THE MARYLAND-NATIONAL CAPITAL PARK AND PLANNING COMMISSION

MEMORANDUM

REVIEW TYPE: Site Plan Review
APPLYING FOR: Approval of 122,620 sf of office and R & D on 5.166 acres
PROJECT NAME: Tyner Property
CASE #: 8-99041.D
REVIEW BASIS: Sec. 59-D-3, M. C. Zoning Ordinance

Tyner
Site
Plan
↙

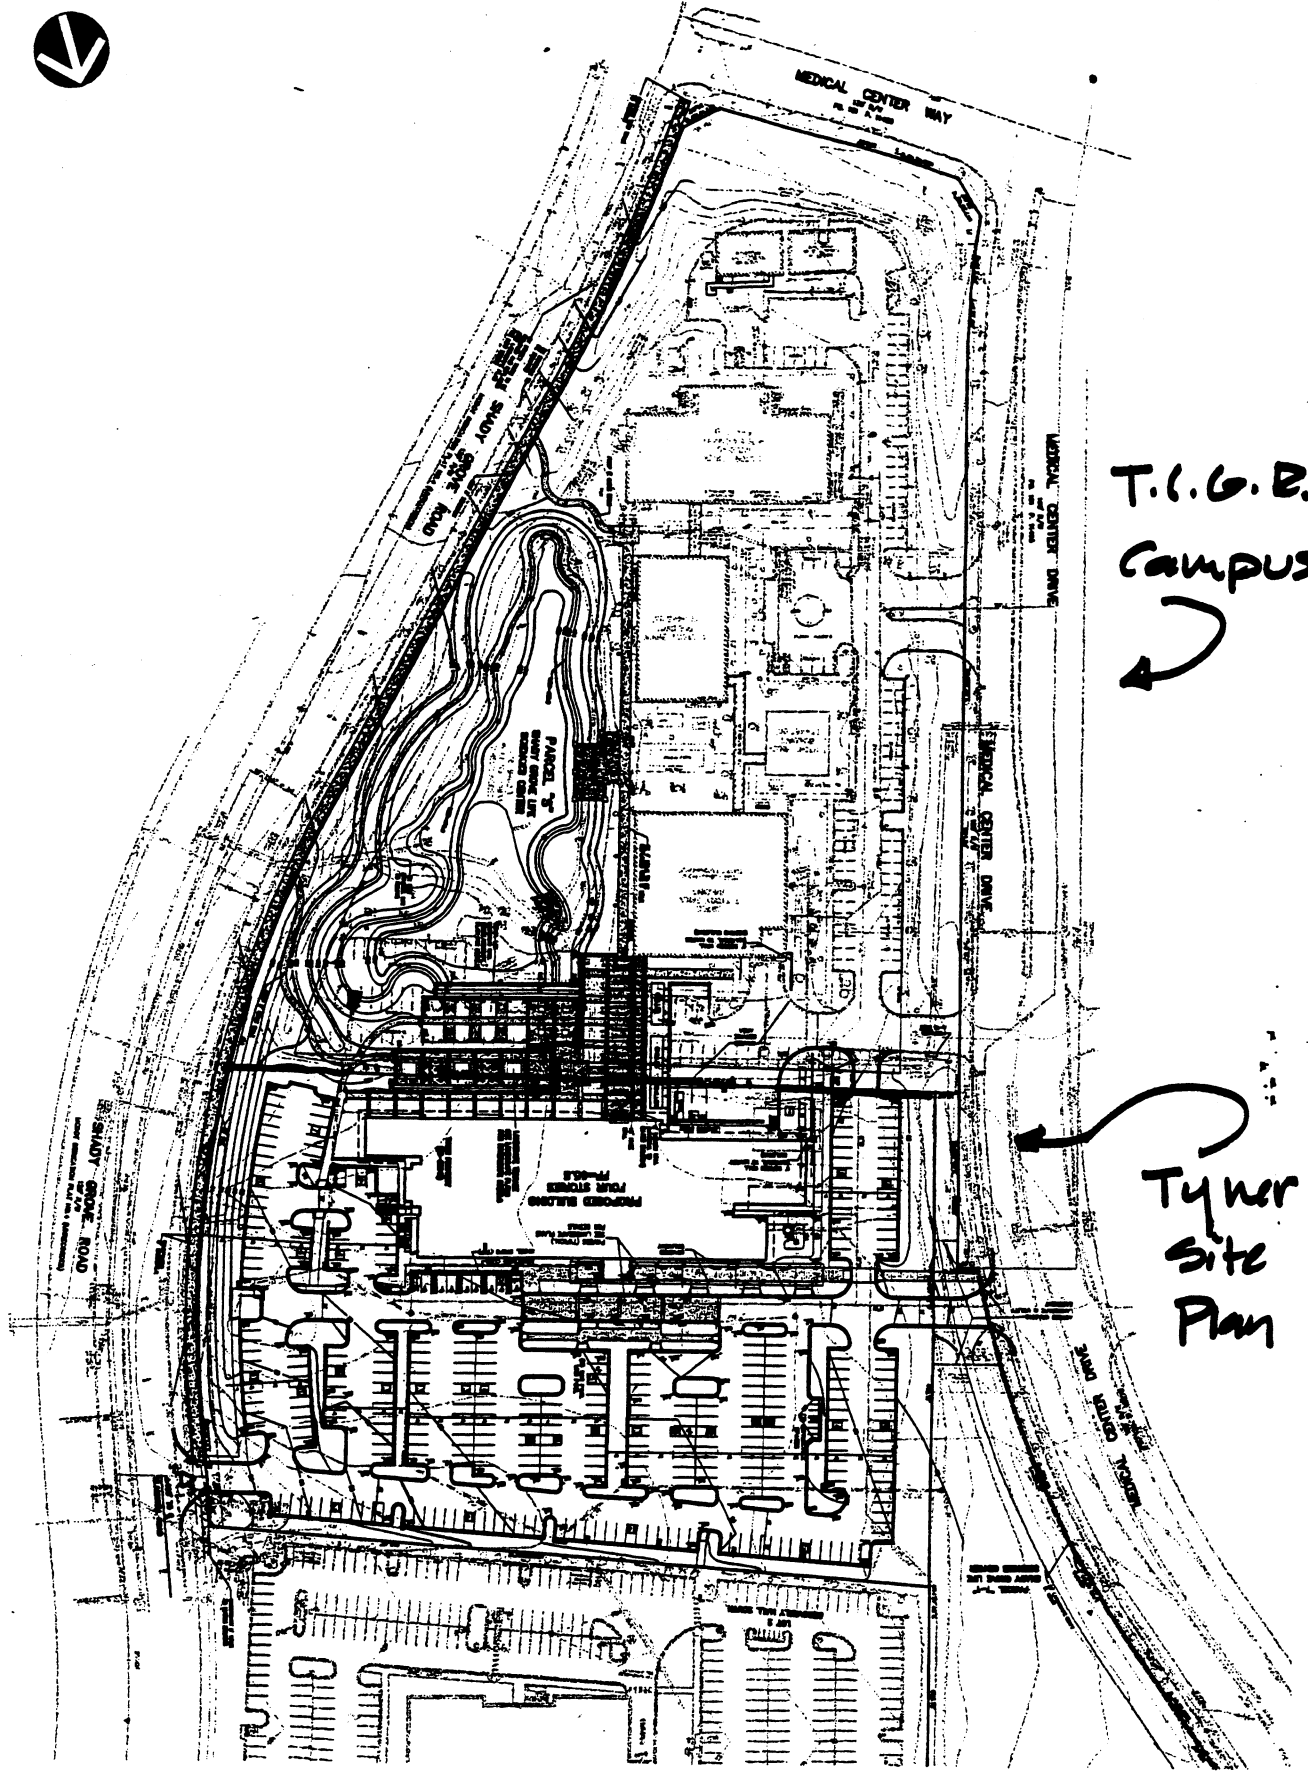
1. Standard Conditions dated October 10, 1995, Appendix A.
2. The Site Plan Enforcement Agreement shall reference an Off-Site Parking agreement per Section 59-E-3.4 of the Zoning Ordinance in regards to the shared parking with the adjacent TIGR Property Site Plan #8-99041.
3. Shade trees shall be added along the edge of the parking lot adjacent to Shady Grove Road.
